Notice of Intent

Type of Action: APD Change

**Procedure Description:** XTO respectfully requests approval to make the below listed changes to the approved sundries. 1. Casing design to be changed from the “4-String Design – Engineered Weak Point” (FIGURE F) to the “4-String Design – Open 1st INT x 2nd INT Annulus” (FIGURE D). An open annulus will be utilized and monitored during completions operations. Post completion, bradenhead squeeze will be performed to tie back the 1st intermediate x 2nd intermediate annulus. TOC will be placed into the 1st intermediate shoe but still below the base of Potash interval. 2. No changes to the cementing, casing or mud circulating system designs will be required for the requested change. 3. There is no new surface disturbance. Please refer to the R-111-Q well bore diagrams in the attachment below reflecting the changes requested. WELL NAME API Number JRU Apache Federal Com 111H 30-015-56010 JRU Apache Federal Com 801H 30-015-56011 JRU Apache Federal Com 901H 30-015-55834 JRU Apache U Federal Com 704H 30-015-56188 JRU Apache Federal Com 705H 30-015-56229 There is no new surface disturbance.

XTO respectfully requests approval to make the below li

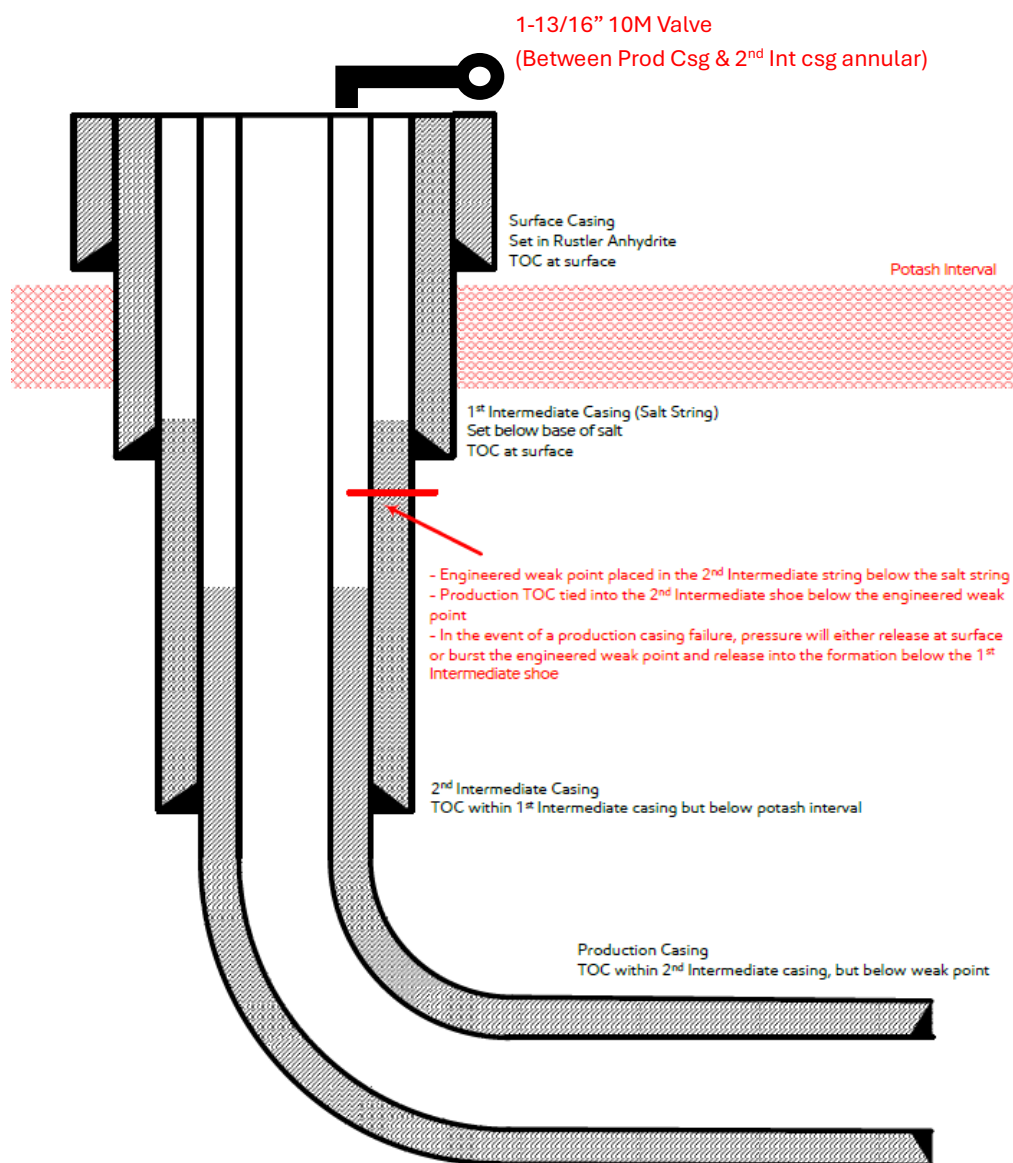
1. Casing design to be changed from the "4-String Design – Engineered Weak Point" (FIGURE F) to the "4-String Design – Open 1<sup>st</sup> INT x 2<sup>nd</sup> INT Annulus" (FIGURE D). An open annulus will be utilized and monitored during completions operations.

Post completion, bradenhead squeeze will be performed to tie back the 1<sup>st</sup> intermediate x 2<sup>nd</sup> intermediate annulus. TOC will be placed into the 1<sup>st</sup> intermediate shoe but still below the base of Potash interval.
